IEEE 802.3cg MDI connectors

Amrik Bains - Cisco Systems
Peter Jones - Cisco Systems

Related Comments

PANDUIT “Copper LC” connector

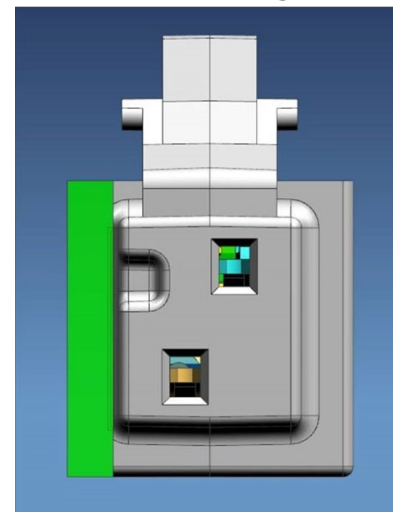
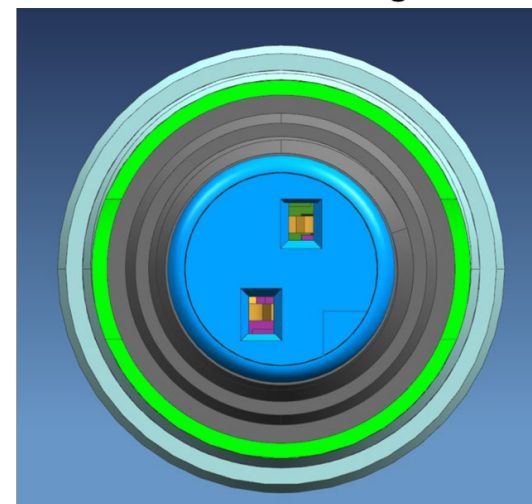
IEC-63171-1 does not yet acknowledge 18AWG conductors

Rated MICE1/MICE2 with shielded connector

Common mating interface
